AVN-20220701.1 TEB0911 readback FAN Sense does not work

Company	Trenz Electronic GmbH
AVN Number	AVN-20220701.1
Title	AVN20220701.1 TEB0911 readback FAN Sense does not work
Subject	Information about FAN Sense value over CPLD I2C interface
Issue Date	2022-07-01

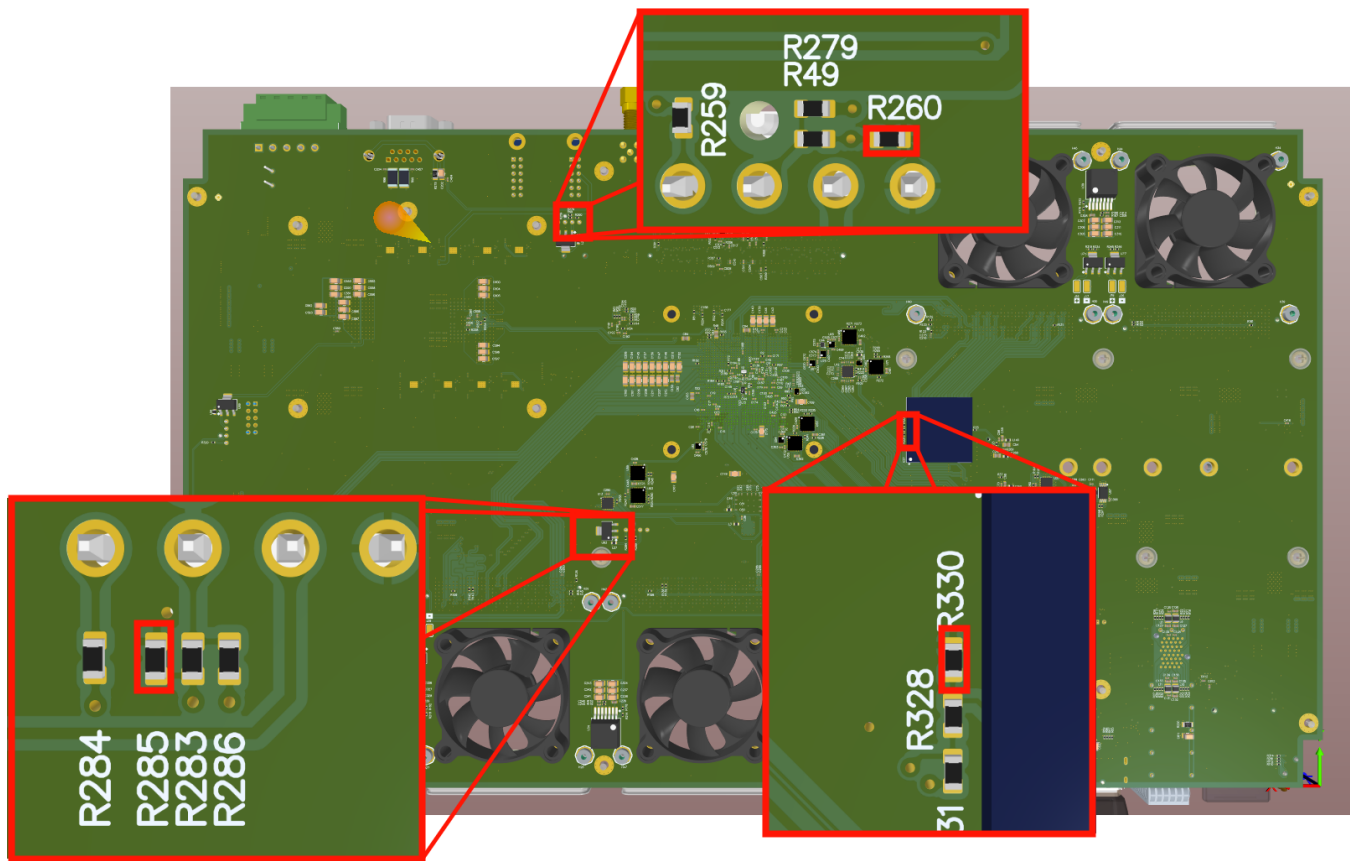
Read back of the FAN SENSE pin is currently not possible due to the following problems

- #1 FAN Logic Level is incorrect
- #2 CPLD I2C Slave Soft IP does not support i2c-get method

#1 Incorrect Voltage Level for F1SENSE, F2SENSE, F3SENSE

Problem can be solved with following HW changes:

1. Remove R285 (connected to F1SENSE)
2. Remove R330 (connected to F2SENSE)
3. Remove R260 (connected to F3SENSE)
